ENSEMBLE				Revision 01			
ELEMENT				RPC RE-4 gas pipes on the periphery of the endcap - patchpanels			
DESIGNED	NAME	DATE	SCHEMATIC	DESIGNED	NAME	DATE	SCHEMATIC
RELEASED	M.Sc. Wojciech Szczęsny	28.01.2014	1:25	RELEASED			
CONTROLLED				CONTROLLED			
APPROVED				APPROVED			
3D maker				CMSYEN3RE4_001_A

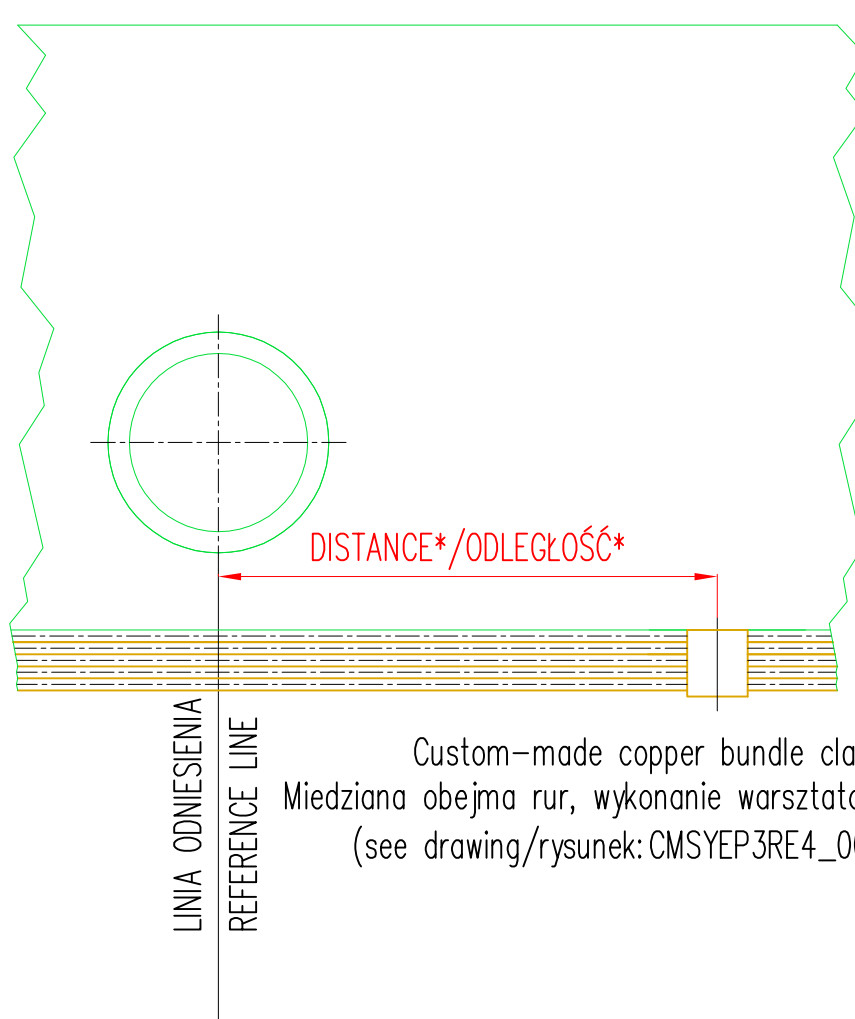
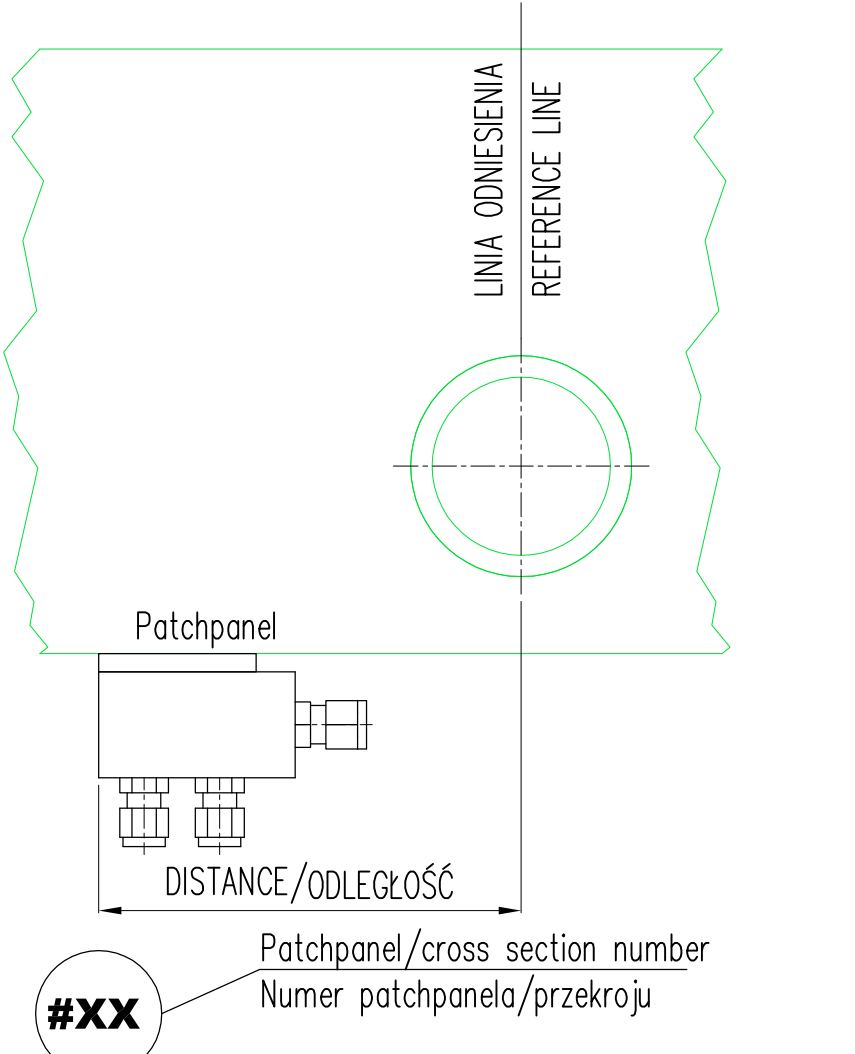
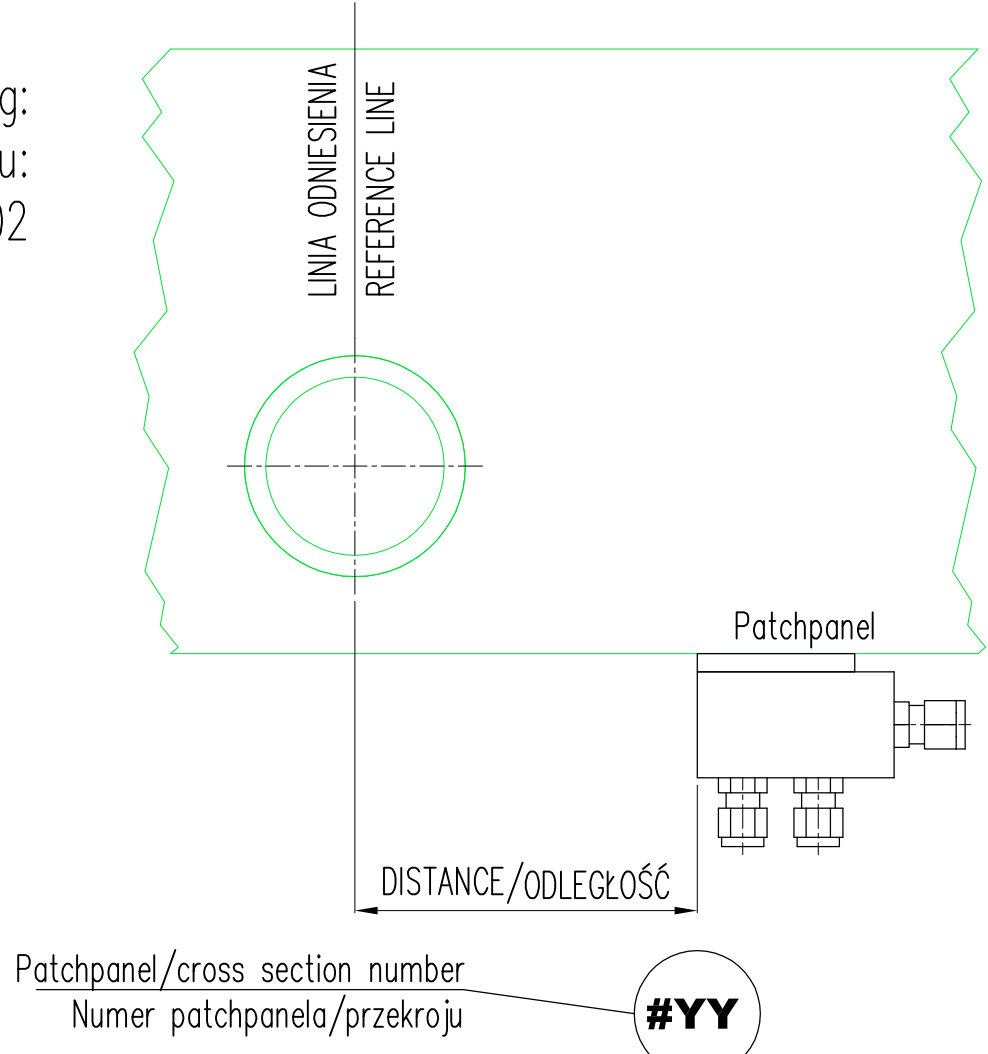
- 11) Positions of patchpanels 13AB, 13 CD, 14AB, 14CD, 15AB and 15CD have been changed in respect to drawing Revision 00.
 - 12) Położenie patchpaneli 13AB, 13 CD, 14AB, 14CD, 15AB i 15CD zostało zmienione w stosunku do rysunku Rewizja 00.
